TECHNICAL MEMORANDUM

TO: The City of McCall, Idaho
FROM: Roland Rocha, P.E.
Luise Winslow E.I.
DATE: August 25, 2023
SUBJECT: McCall 6 Subdivision
JOB NO.: 733-23-02.2023.08.14

Bowen, Collins, and Associates has reviewed the proposed McCall 6 Subdivision projected water demands. We offer the following observations and comments for your consideration:

Figure 2. Proposed Site Plan Reviewed.

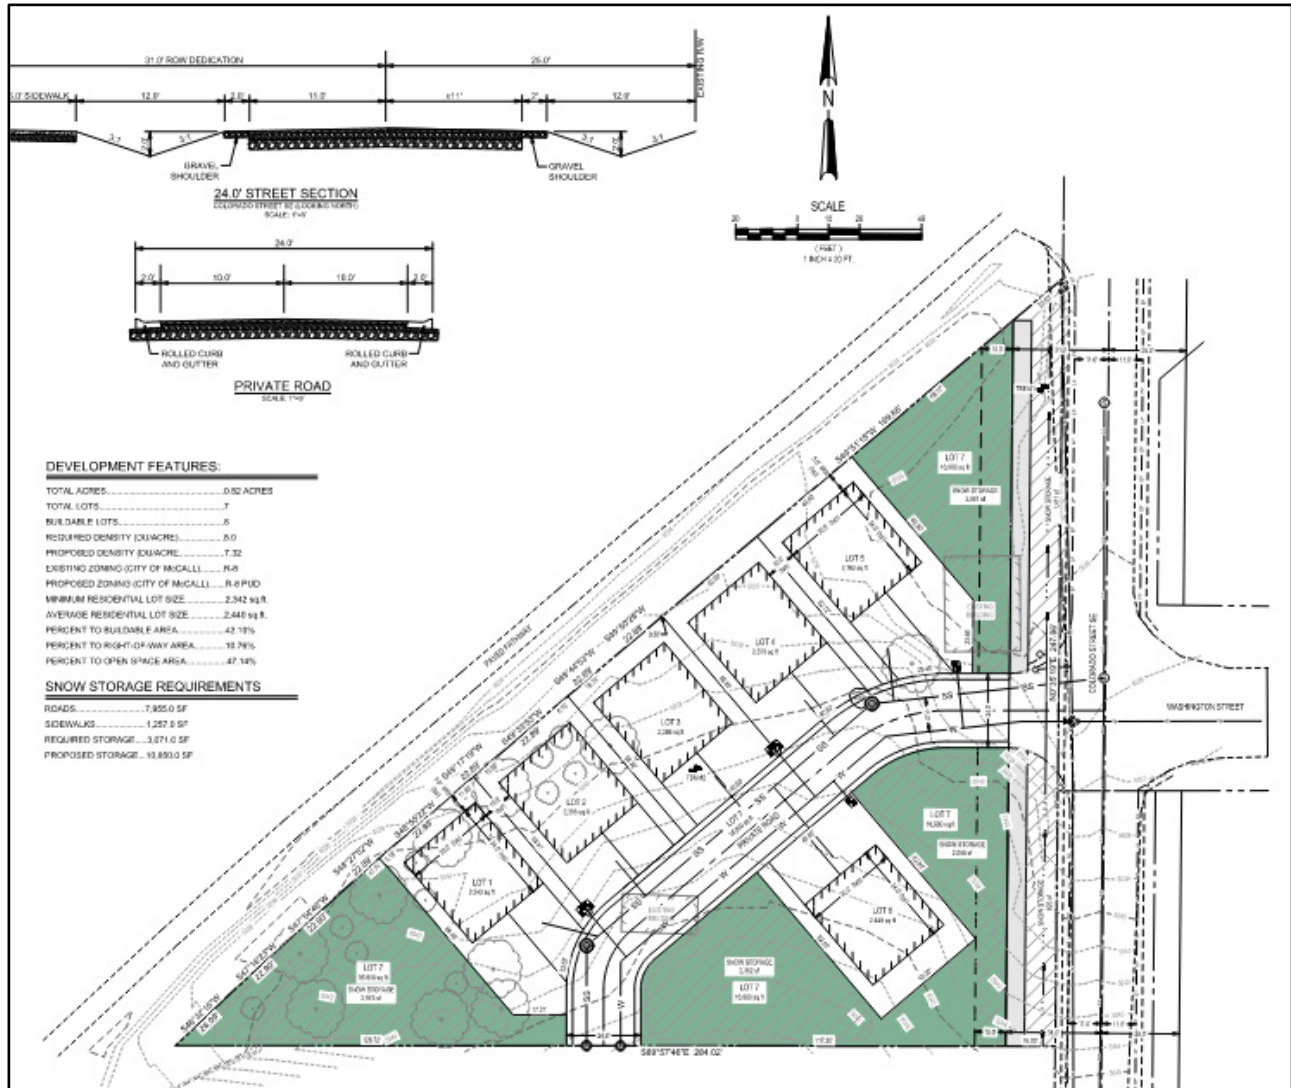
The development was added to the City's existing water model and evaluated for system pressures. The proposed layout is a single 8-inch water main running through the development connected with a connection to the distribution to the north and a dead end to the south. The McCall 6 subdivision was evaluated independently from the proposed Wood Moor Crest Subdivision.

The additional demand from this development is not likely to create a noticeable difference in water pressure for the existing residents in the area. The maximum day demand water pressures in the development will range from **57-63 psi** assuming a 5 psi buffer. Peak hour demand pressures will be approximately **54-60 psi** assuming a 5 psi buffer. This is above the state required 40 psi for peak hour demands.

Under the proposed pipeline layout and conditions, the safe available fire flow to the development is **875 gpm**. The model assumes fire flow is delivered under a maximum day demand scenario.

Figure 3. Model Results and Recommendations.

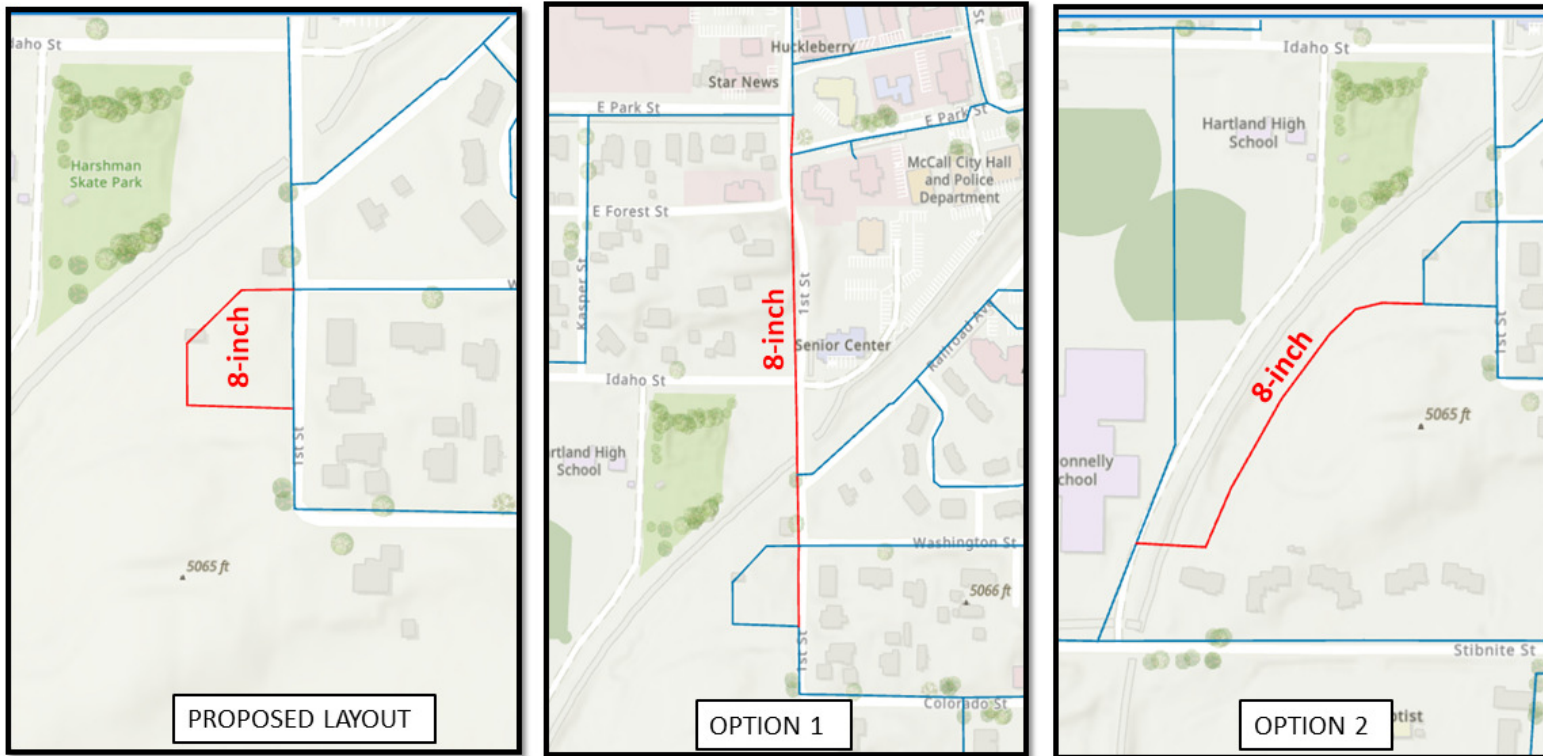
The proposed Wood Moor Crest Subdivision is located immediately south of McCall 6 and includes an 8-inch water main running through the development. If developers connected the dead end in McCall 6 to the Wood Moor Crest pipeline, they could increase available fire flow in both subdivisions.

Figure 3 illustrates the recommendations. Loop the proposed dead end to improve water quality and water pressures and increase available fire flow to 1,500 gpm. This can be accomplished a few different ways:

1. Extending the dead end to connect with 1st Street and increase the existing 6" pipe along 1st Street to at least an 8" pipe. A 12" inch pipe is better for the overall system. This larger pipe should extend across the development frontage along 1st Street to Park Street.
2. Connecting the dead end to 8" water main near McCall Donnelly Highschool. This could be done in conjunction with the proposed Wood Moor Crest Subdivision
